**\*\*\* AGENDA \*\*\***  
**CITY PLANNING COMMISSION**  
**J. MARTIN GRIESEL ROOM**  
**TWO CENTENNIAL PLAZA – SUITE 720**  
**805 CENTRAL AVENUE**

**July 7, 2017**  
**9:00 AM**

A report and recommendation on a Subdivision Improvement Plan for the Sanctuary at River Green Subdivision in California.

# Sanctuary at River Green Subdivision Improvement Plan

**OVERALL SITE PLAN**  
PANAMA & RENSSELAER, CITY OF CINCINNATI, HAMILTON  
COUNTY, OHIO

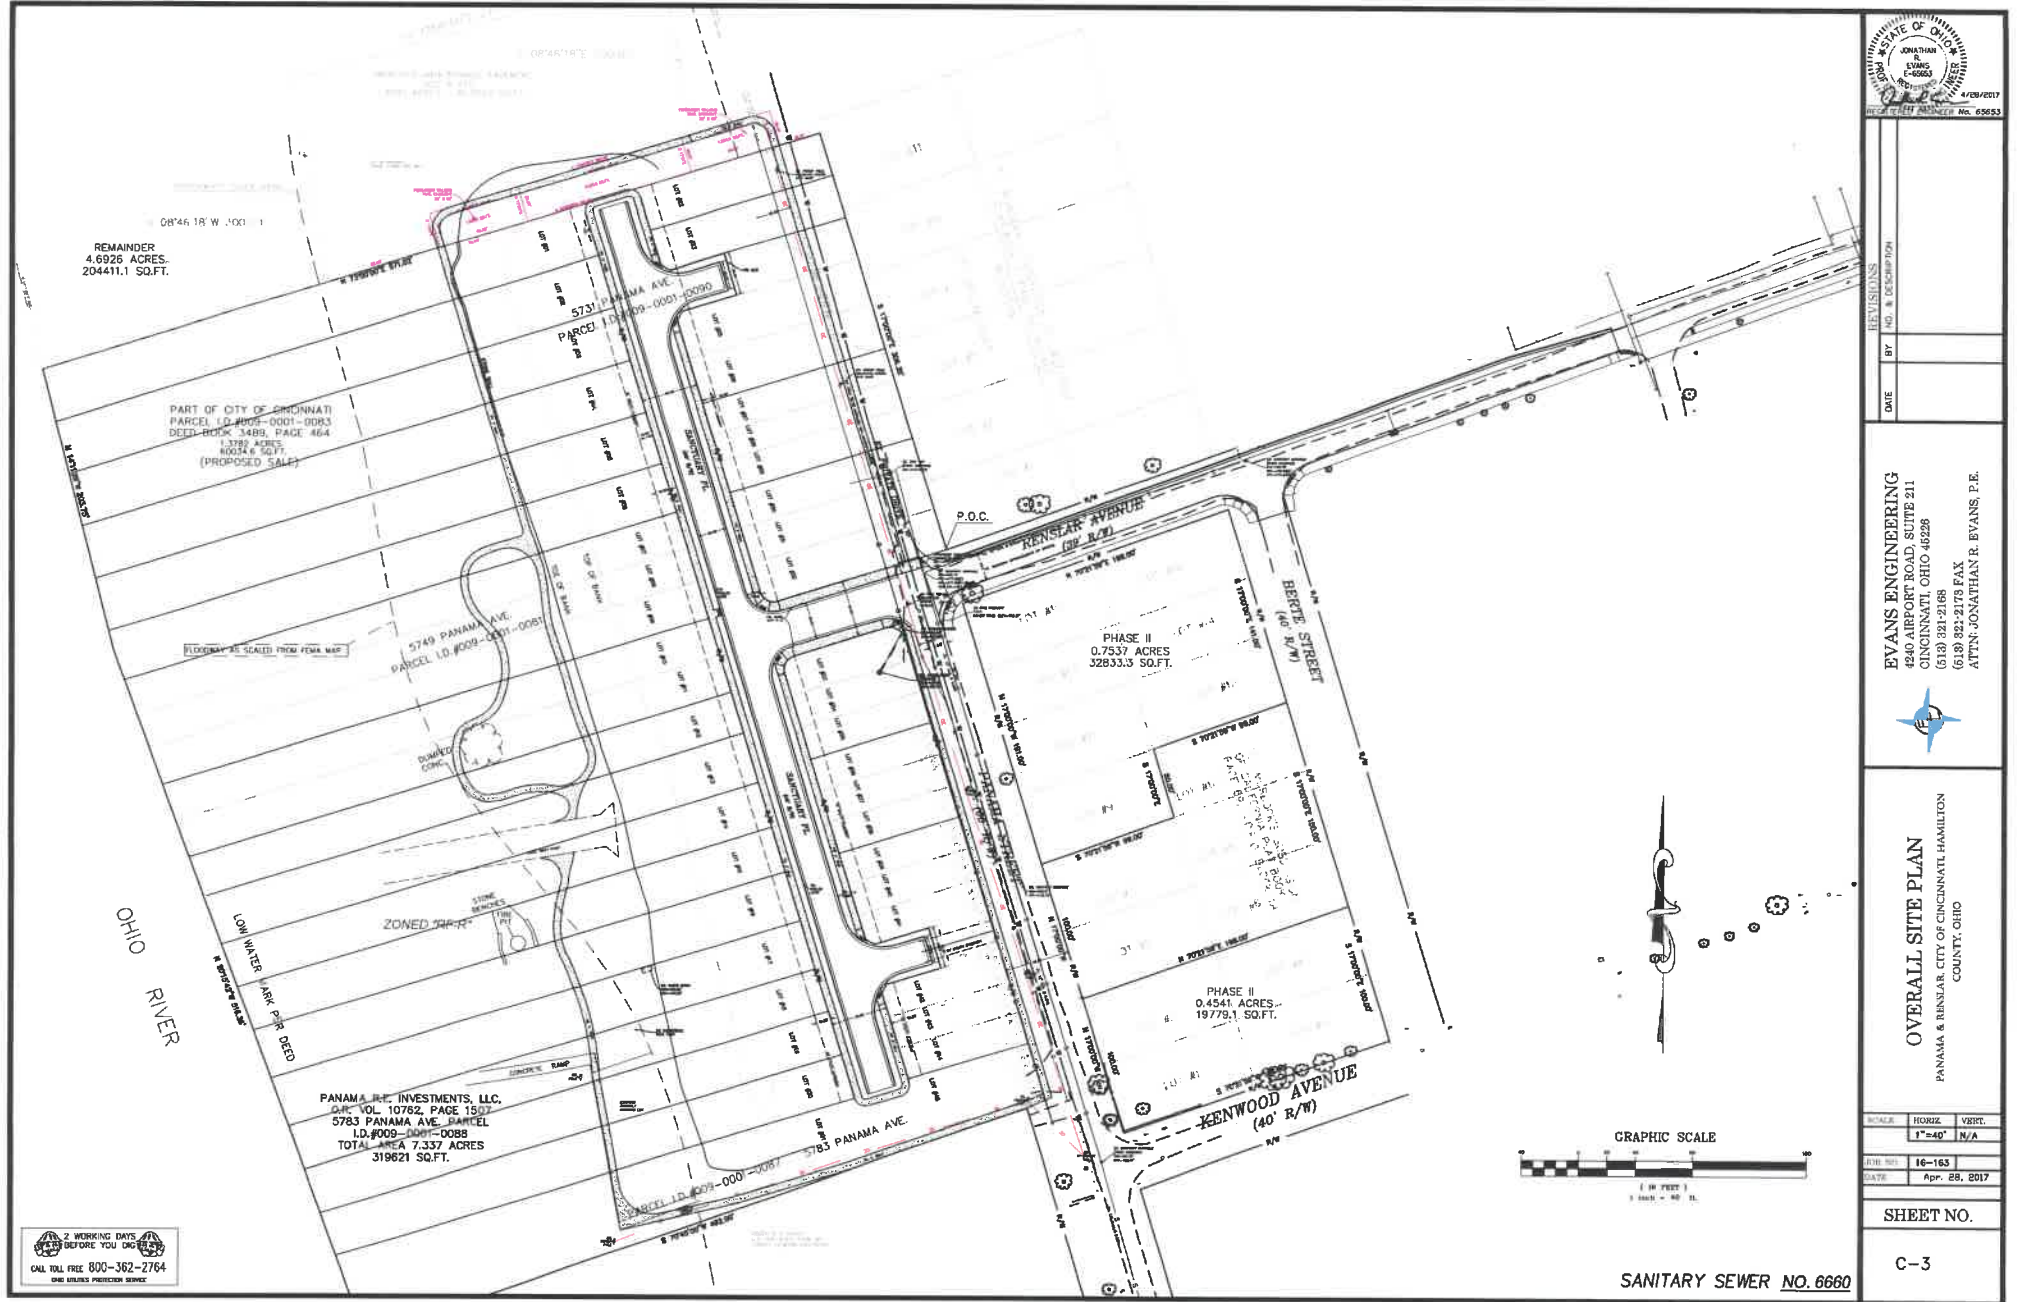
Sheet C-3 –

#### Sheet C-3 –

**GRADING PLAN**  
PANAMA & RENSSELAER, CITY OF CINCINNATI, HAMILTON  
COUNTY, OHIO

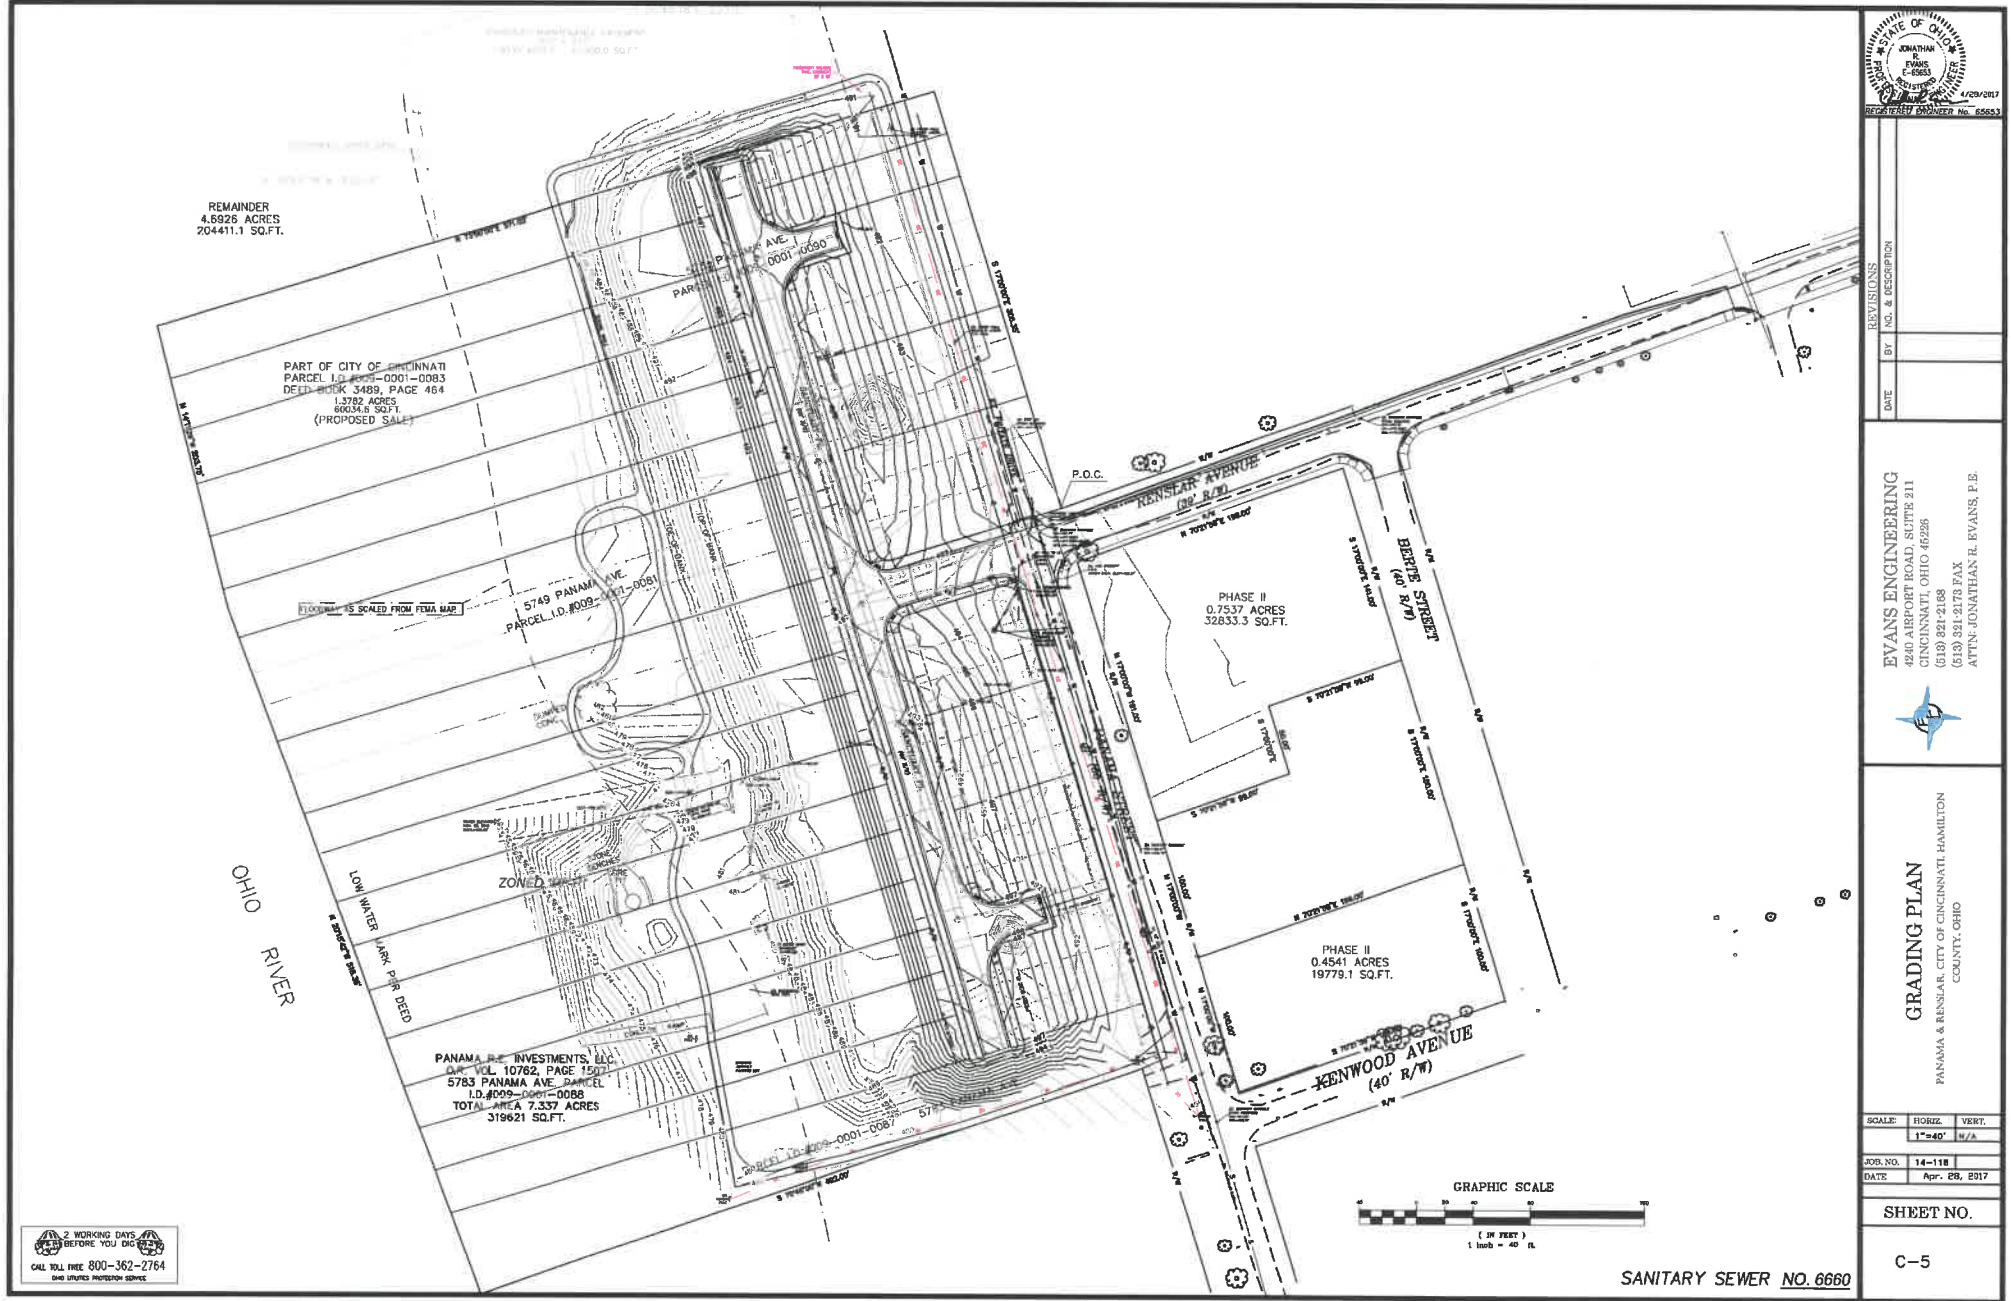
### Sheet C-5 –

### Sheet C-5 –
